ORDINANCE NO. 2025-28

AN ORDINANCE OF THE CITY OF NORTH PORT, FLORIDA, AMENDING THE CENTRAL PARC AT NORTH PORT (ACTIVITY CENTER 9) PATTERN PLAN TO REVISE THE BUFFER PLAN; AMENDING ARTICLE III, TABLE 3.3.1.2: DIMENSIONAL STANDARDS AND ARTICLE IV, DEVELOPMENT STANDARDS OF THE UNIFIED LAND DEVELOPMENT CODE TO REFERENCE THE AMENDED CENTRAL PARC AT NORTH PORT PATTERN PLAN; PROVIDING FOR FINDINGS; PROVIDING FOR CONFLICTS; PROVIDING FOR SEVERABILITY; PROVIDING FOR CODIFICATION; AND PROVIDING AN EFFECTIVE DATE.

Planned Community Development (PCD) Pattern Plan

Amended October 28, 2025, Ordinance No. 2025-28

07 AMENDED Buffer Plan

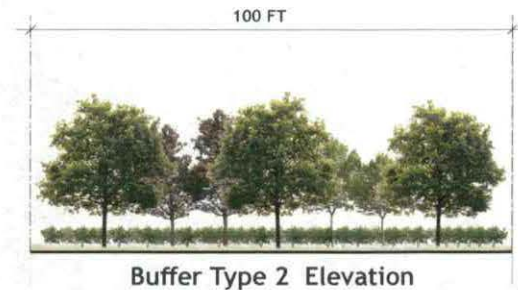
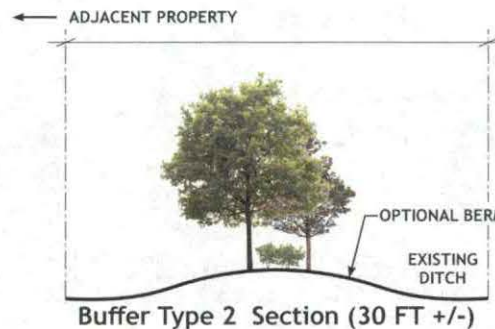
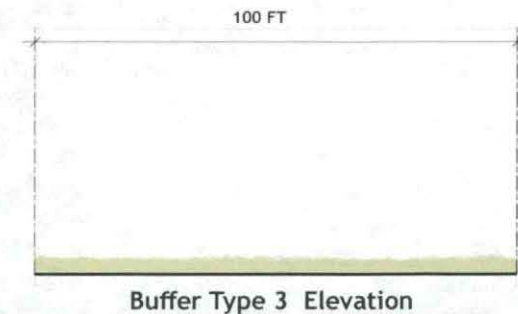
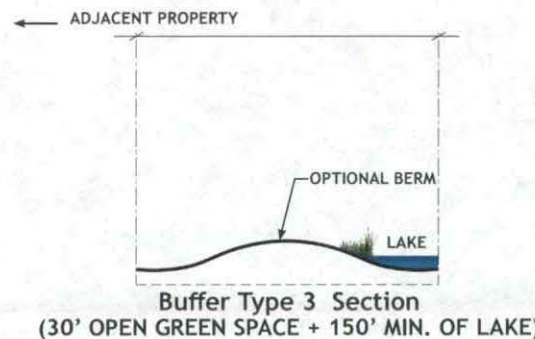
Buffer Type 1 (Typical 100 FT)

- 3 Canopy Trees
- 3 Understory Trees
- 30 Shrubs (can be grouped together)
- 3 FT to 5 FT high berm (Maximum 4:1 (H:V) side slopes)

Buffer Type 2 (Typical 100 FT)

- 3 Canopy Trees
- 3 Understory Trees
- 30 Shrubs (can be grouped together)
- Optional 1FT to 3FT high berm (Maximum 4:1 (H:V) side slopes)

Buffer Type 3 (Typical 100 FT)

- Sod
- Optional 1FT to 3FT High Berm (Maximum 4:1 (H:V) side slopes)

07**AMENDED Buffer Plan**Central Parc at North Port Planned Community
Development (PCD) Pattern Plan**FOOTNOTES**

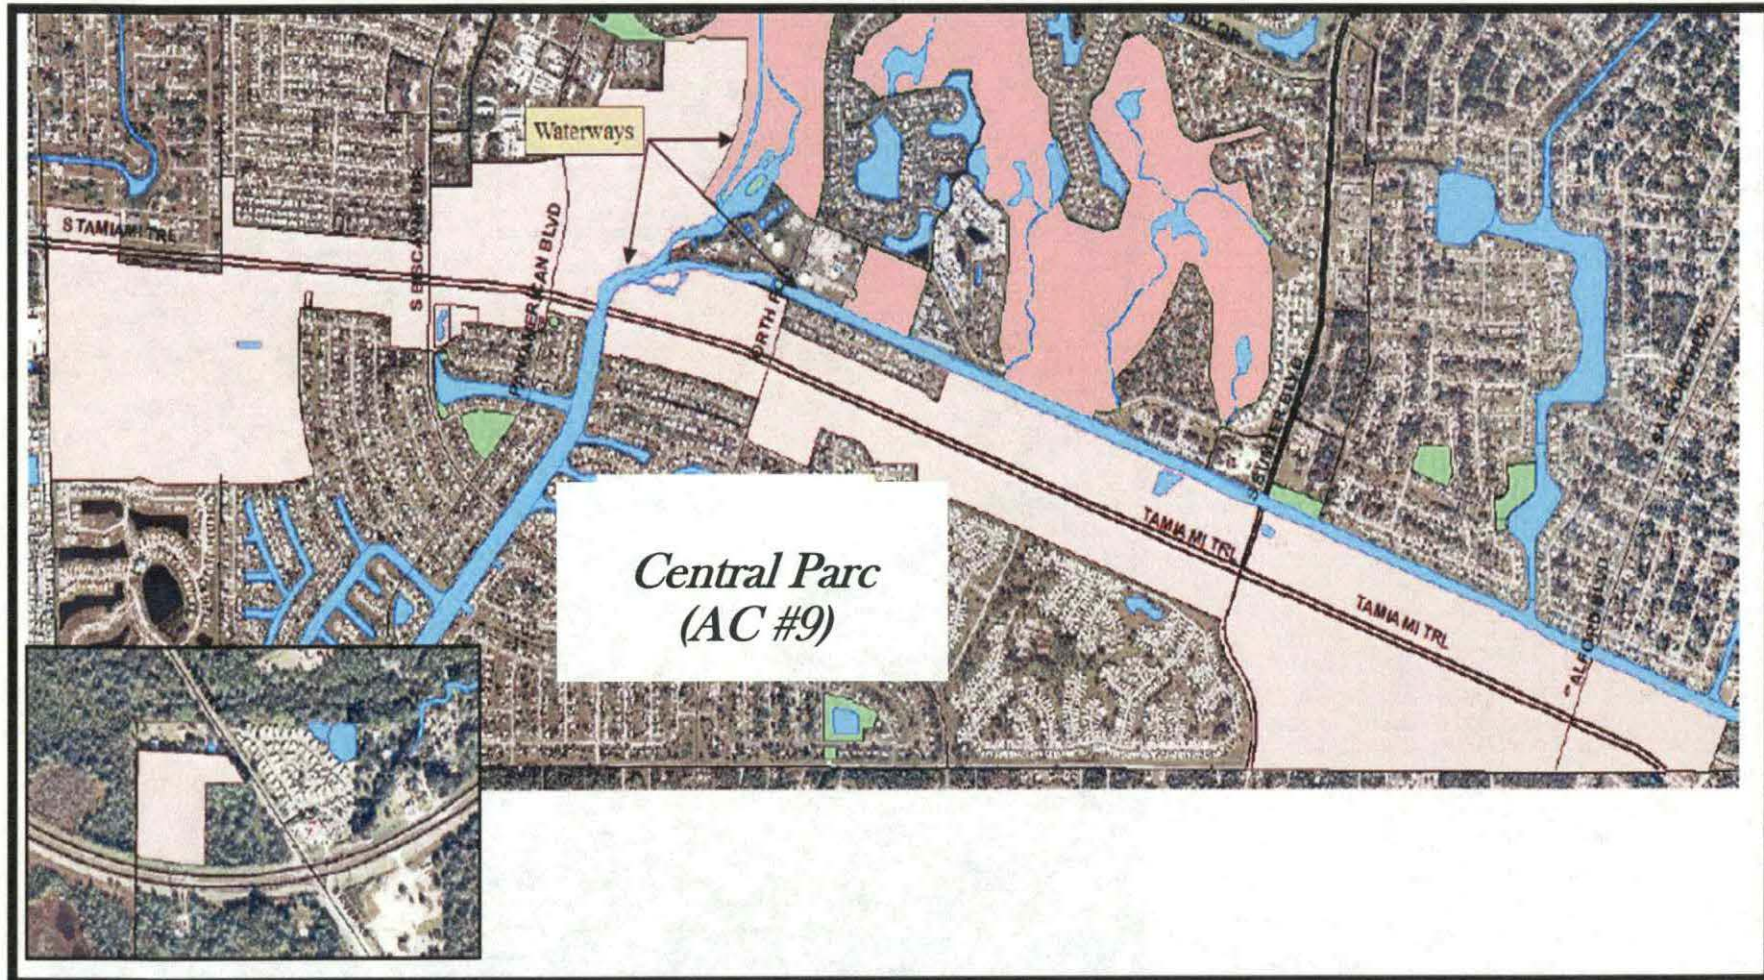
1. BUFFER 2 ADJACENT TO LAKE 9 CONSISTS OF THE EXISTING 10 OAK TREES AND SHRUBS PLANTINGS PER THE TYPICAL SECTION.

2. INSTALL 200 LF OF BUFFER 2 ALONG THE REAR OF LAKE 13 BEHIND 5435, 5441, 5445, AND 5449 APPOMATTOX DRIVE.
